Enquiries to	Jonny Elliott	My reference	060627
Direct Line	N/A	Your reference	O/26/101417
Date	13 August 2026	Email	eastleighdc@hants.gov.uk

**Re: O/26/101417 At Land adjacent to Windhover Roundabout, Bursledon,
Bursledon Road, Bursledon, SO31 8BN**

**Outline planning application (all matters reserved except for access) for
employment development (Use Class B2/B8) of up to 18,580 square
metres together with ancillary offices (Use Class E(g)(i)) and other
ancillary buildings, structures, parking, servicing and manoeuvring
areas, landscaping and sustainable urban drainage features, following
demolition of existing buildings**

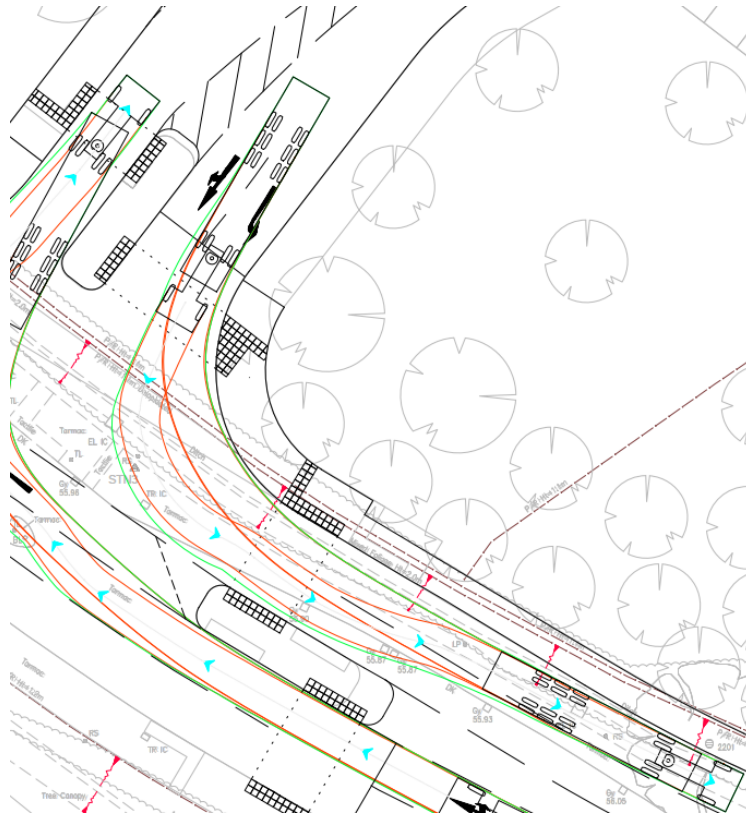
Drawing 1803014-TK01 C illustrates a max legal length HGV ingressing and egressing the junction. The right turn manoeuvre into the site is very tight and would require a HGV to position itself perfectly and not continue in the ahead lane, blocking the junction. There is a high probability that the HGV will partially obstruct the ahead traffic in the westbound offside lane. To avoid ahead drivers attempting to steer around the back of the HGV the right turning storage area within the junction would need to be wider to ensure it can fully accommodate an HGV.

The left turn movement out of the site shows the HGV in an unnatural position, and appears to be positioned across both exit lanes:

The merge on the westbound Bursledon Road exit is very short and does not provide clear priorities. Geometrically the generally slower moving nearside lane traffic would need to merge into the faster moving offside lane traffic. As shown, it is unacceptable and would need to be significantly improved. This would require the merge distance to be extended and for the offside lane to clearly merge into the nearside lane. Furthermore, waiting eastbound right-turning traffic is directly next to the merge, with no separation or kerb, which could result in head on conflict. Centre hatching would also be required in this area to separate the opposing traffic.

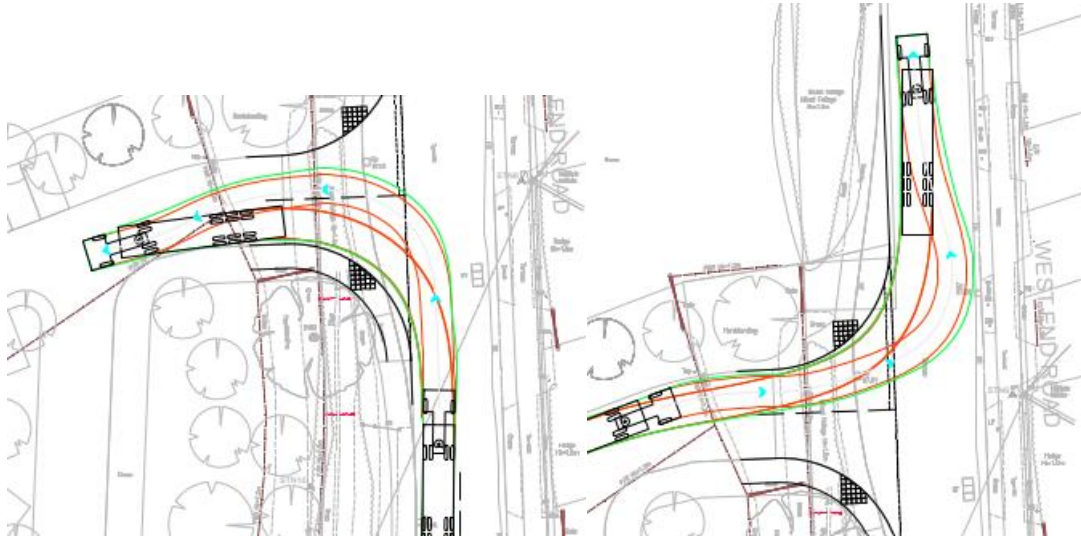
The submitted drawings show a red dashed line which is assumed to be represent the highway boundary. There are also banking 'tadpoles' which are also shown in red, and further clarity is required on these points.

Junction visibility splays are shown as 2.4m x 120m in each direction, and a 2.4m x 90m visibility splay has also been shown. While it accepted that the 120m visibility splay to the south is not appropriate given the amount of land take necessary, the revised 90m visibility splays are also considered to be unacceptable at this time. In accordance with HCC Technical Guidance Note 3, Stopping Sight Distances (SSD) and visibility splays must be based on surveyed vehicle speeds. On this basis, two speed surveys should be undertaken in order to calculate the required junction visibility splays.
